CLUB RACING BOARD MINUTES | September 2, 2025

1. #39016 (Club Racing Board) Replace GCR Section 9.1.6.

FIGURE 1 VALVE SEAT CUTTING DIMENSIONS

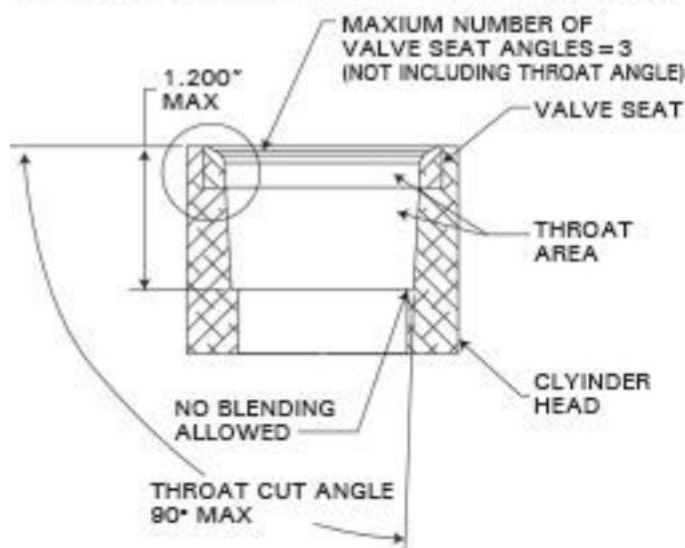
m. Only stock, steel, or stainless steel intake and exhaust valves are permitted. Titanium or titanium alloy valves are not permitted. Valve seat specifications shall comply with Section F – Engine Build Sheets, Drawing 1. Valve length and valve stem installed height is open. Any valve seal may be used.

n. A valve job will consist of 3 valve angles only not including the throat cut angle. Each of these valve angles is open. The widths of the valve angles on the head and on the valve are open. The maximum diameter of the cut in each valve seat is .250 inches greater than the diameter of its valve head. All valve cuts must be concentric with the valve stem. Additional valve specifications are listed in Section F – Engine Build Sheets. Valve seat specifications shall comply with Section F – Engine Build Sheets, Drawing 1.

FIGURE 2 ALUMINUM CYLINDER HEAD REPAIR ZONE

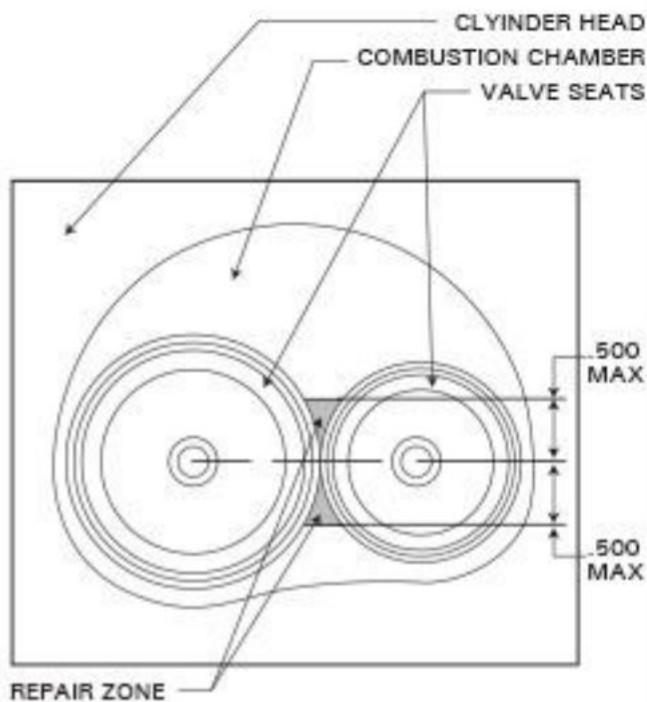
l. The combustion chamber may be repaired or modified in the area shown in Section F – Engine Build Sheets, Drawing 2 to repair or prevent pitting or damage between the intake and exhaust valves. For this repair or modification, it is permissible for the valve seats to contact each in the area shown in Section F, Drawing 2. This repair/modification may serve no other purpose.
